# Staff Report

To: Salt Lake City Historic Landmark Commission  
From: Carl Leith, Senior Planner  
801 535 7758 or [carl.leith@slcgov.com](mailto:carl.leith@slcgov.com)  
Date: January 7, 2016  
Re: PLNHLC2015-00930 New Construction  
PLNHLC2015-00931 Special Exception

## NEW CONSTRUCTION – APARTMENT BUILDING

**PROPERTY ADDRESS:** 454-466 SOUTH TEMPLE  
**PARCEL ID:** 1606202008, 1606202009  
**HISTORIC DISTRICT:** South Temple Local Historic District  
**ZONING DISTRICT:** H Historic Preservation Overlay District. R-MU (Residential/Mixed Use District)  
**MASTER PLAN:** Central Community Master Plan  
**DESIGN GUIDELINES:** Multi-Family

**SPECIAL EXCEPTION**

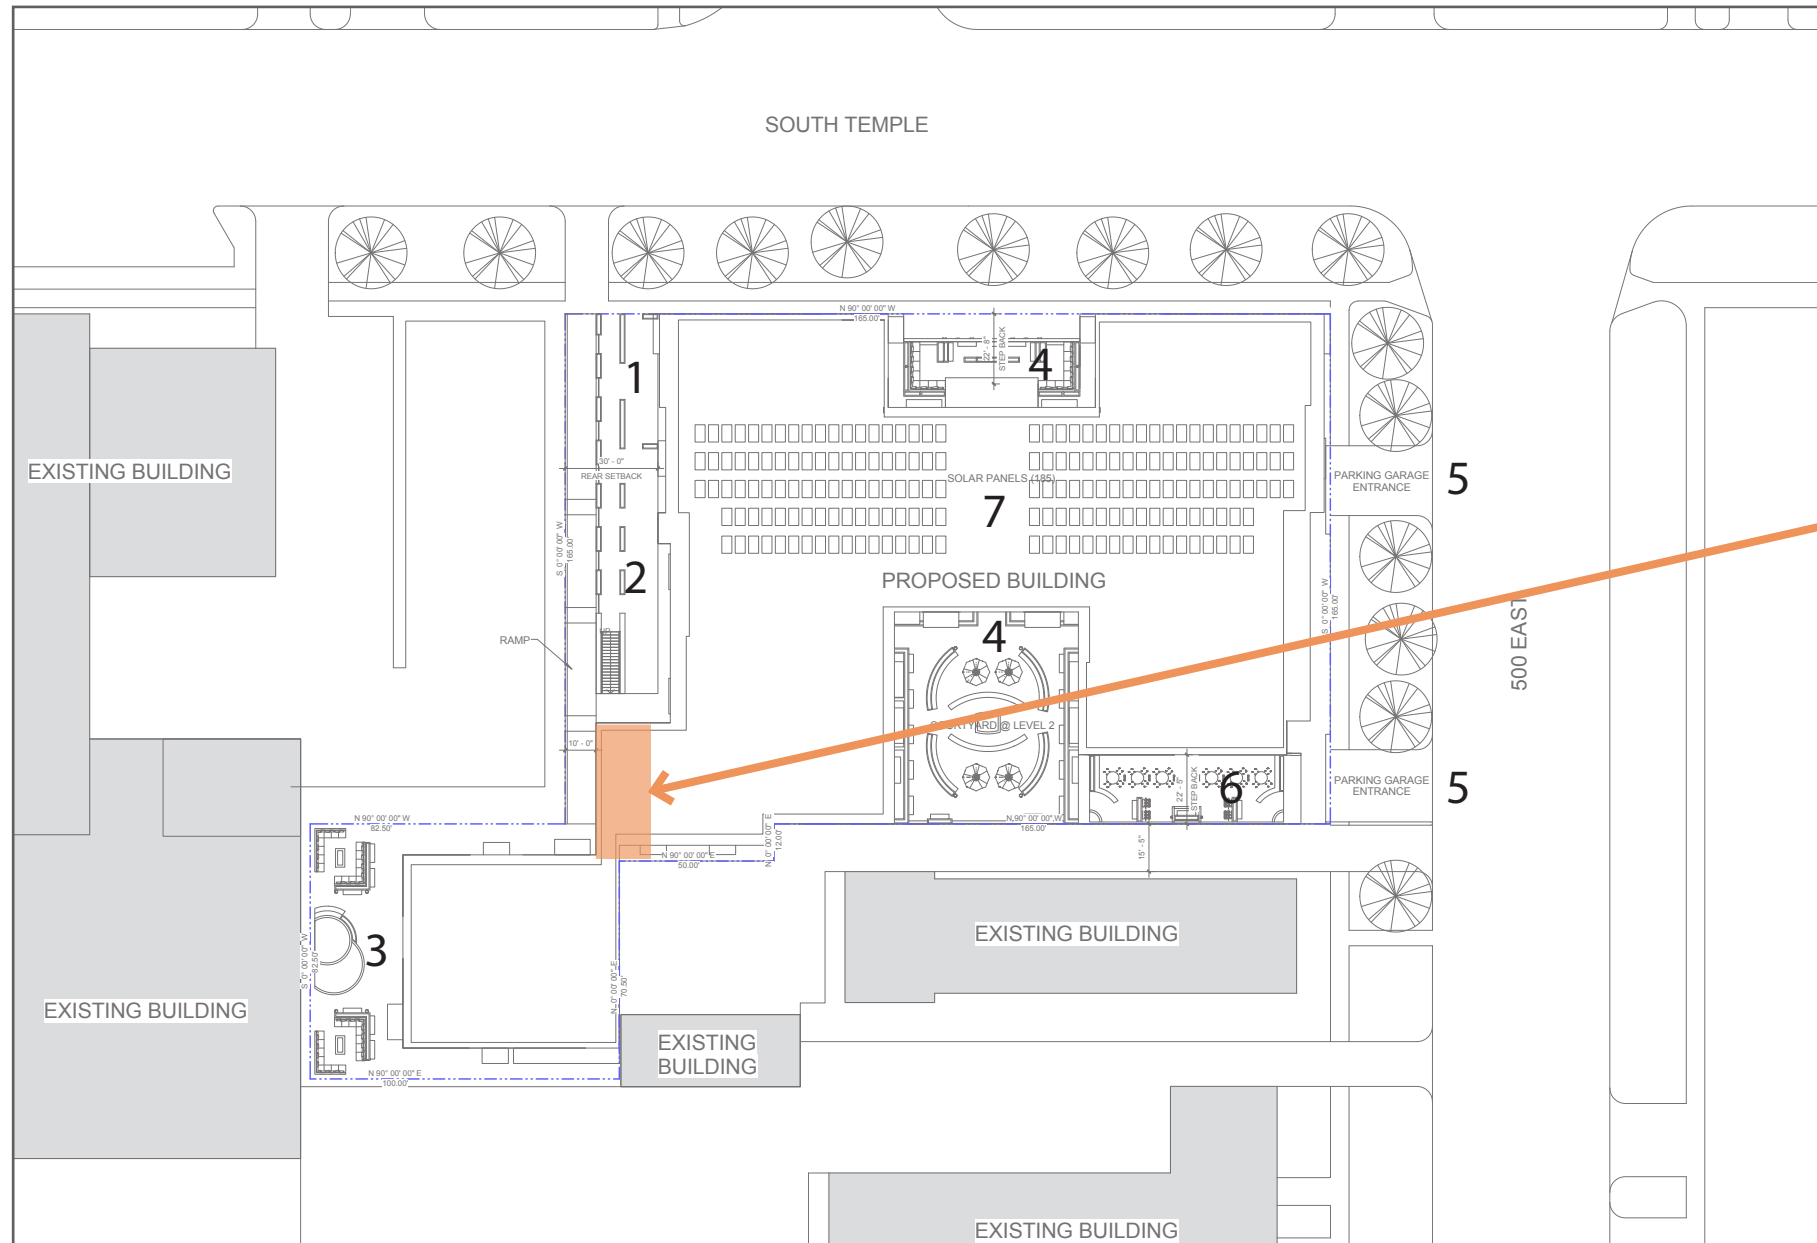
To construct the proposed building the applicant is seeking Special Exception approval for encroachment of approximately 20ft into required rear setbacks towards the SW corner of the site. Two stairways and an ADA ramp are in excess of 4 ft in height within the rear setback. With the reduction in established grade proceeding south across the site, the proposed building would be in excess of the 75' R-MU base zone height ceiling, with height extending to 82' 4" along the south facades, thus approximately 7' 4" in excess of the R-MU maximum height. Vehicle access ramps will occasion a grade change in excess of 4 ft. The applicant seeks approval in these respects.

**Discussion:** In order to construct the proposed development as proposed, special exception approval is sought for an encroachment of 20 feet into the required rear yard setback on the west side of the development to accommodate part of the building, two stair ways and an ADA ramp that are greater than 4 feet in height. In conjunction with the encroachment, the applicant is seeking a special exception for approximately 7 feet 4 inches in additional building height for a portion of the west elevation and a portion of the south elevation at the southwest corner of the site. A grade change greater than four feet is also requested in order to accommodate the parking access ramp.

A SPECIAL EXCEPTION IS BEING REQUESTED TO ALLOW THE DEVELOPMENT ON THE SOUTHWEST CORNER OF THE PROPERTY. THIS PORTION OF THE PROPERTY IS UNDEVELOPABLE WITHOUT ALLOWING CONSTRUCTION TO OCCUR WITHIN THE REAR SETBACK OF THE 30' SETBACK ALONG THE WEST PROPERTY LINE. THERE IS A VERY NARROW OPENING BETWEEN THE TWO PROPERTIES AND WITHOUT ENCROACHING ON THE BACK OF 30' SETBACK THAT INTERIOR PIECE OF PROPERTY CANNOT BE DEVELOPED. THE ENCROACHMENT IS 20'-0" WIDE BY 42'-2" DEEP

EAST ELEVATION

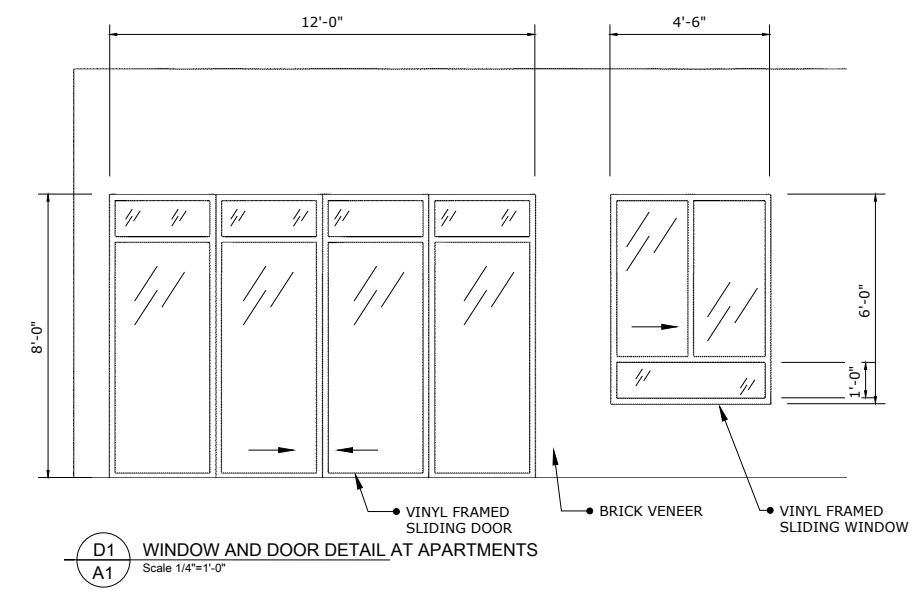
Current Evaluation: The revised design for the building would extend the commercial space and frontage further south on the 500 East façade. The façade is also completely redesigned, while retaining the two vehicular access ramps and openings flanking a brick clad wall framing a sequence of five horizontally proportioned window openings to the parking deck. The background material proposed for this one and then two story section of the façade is identified as 'architectural concrete' using a panel system. Deeper commercial space and extended frontage on this street façade acknowledges previously expressed concerns with viability and street character. Parking ramp access shutters/doors are now defined on the elevations. The window openings to the main level parking deck appear to be open. While the design of the façade to the main level and lower level is consistent with the revised design for the building overall it tends to pay less attention to the slope of the street in defining the different levels within the building, thus losing something in terms of human scale definition in the composition, when compared with the previous design approach. An aspect of the character of 500 East and its role in providing a series of vehicular access points was argued and acknowledged in previous review. It remains in Staff evaluation an important street, on the west side within the South Temple Historic District, and one the east within the Central City Historic District as well as South Temple. Current and future proposals for this street should focus on the potential to not only retain but where appropriate enhance its character and street vitality. It does not seem appropriate in the stewardship of the city's historic resources to focus upon negatives in designing future character, particularly where these negatives are not readily defined as part of that historic character. In that context it remains the Staff evaluation that more can be achieved with the design of this building to contribute to

Current Evaluation: The outline of the Piccadilly Apartment building is now shown on the East Elevation in the revised proposals. The step down in the building height of the proposal immediately adjacent to this building is retained, was acknowledged as a positive in previous review, and is perhaps further defined in the revised design. The south facing court for the apartments is also retained to reduce the impact of the proposals on this building. The juxtaposition between the Piccadilly and vehicle access opening remains, while the five story height of the proposal immediately facing the north façade of the Piccadilly also remains. Both would have a less than positive impact on the amenities enjoyed by the Piccadilly residents. More design consideration might usefully be given to how this initially five story and then two story flank wall along the south façade might be defined, detailed and embellished to relieve what might otherwise be a stark setting and enclosure for the adjacent building and site.
